UNITED STATES PATENT AND TRADEMARK OFFICE

10/599,303

Office Action Summary	Application No. 10/599,303	Applicant(s) GRAPHENIUS, JONAS	
	Examiner MICHAEL D. DAVID	Art Unit 3641

DETAILED ACTION

-Modified figure reproduced from Morgan (US Patent 4090005)-

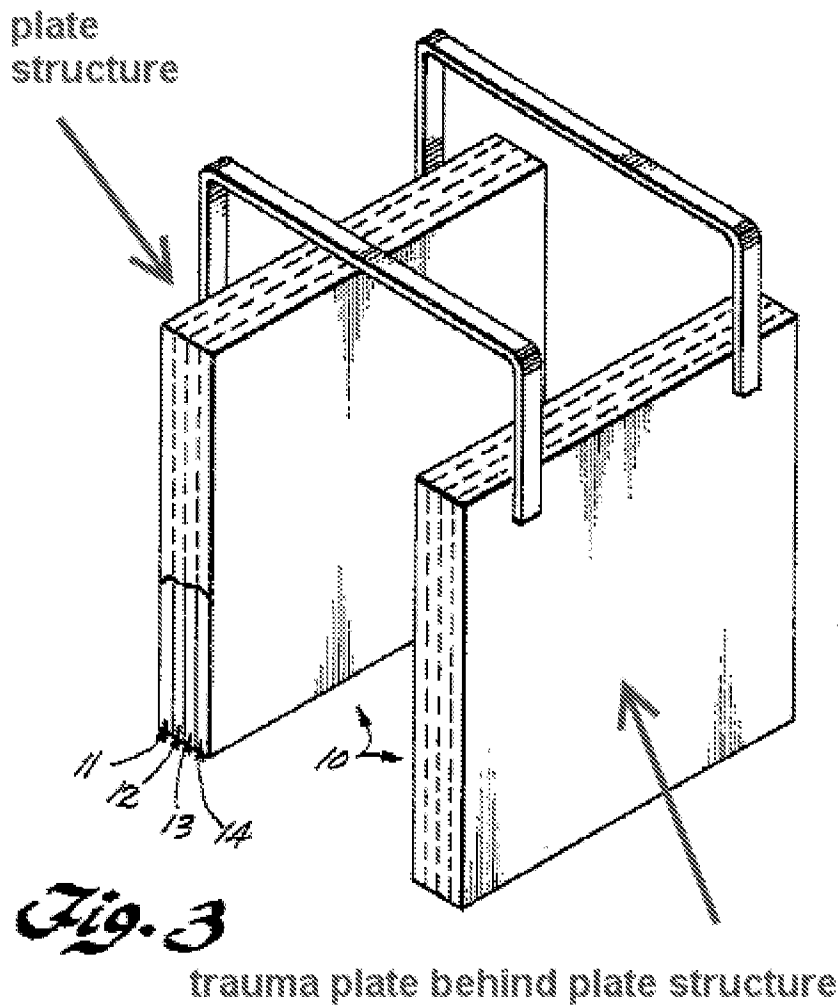
Regarding claim 7, Morgan discloses the method of claim 1 wherein the method further comprises placing a trauma plate behind the plate structure (see fig. 3 below).

Regarding claim 10, Morgan discloses wherein the method further comprises providing a second textile layer and a second semi-solid layer (fig. 3 shows two of the same panels/stacks, one being in front of the person and one being in the back. since there two stacks/panels are identical, the second stack/panel has a second textile layer and second semi-solid layer). See claim 1 rejection above.
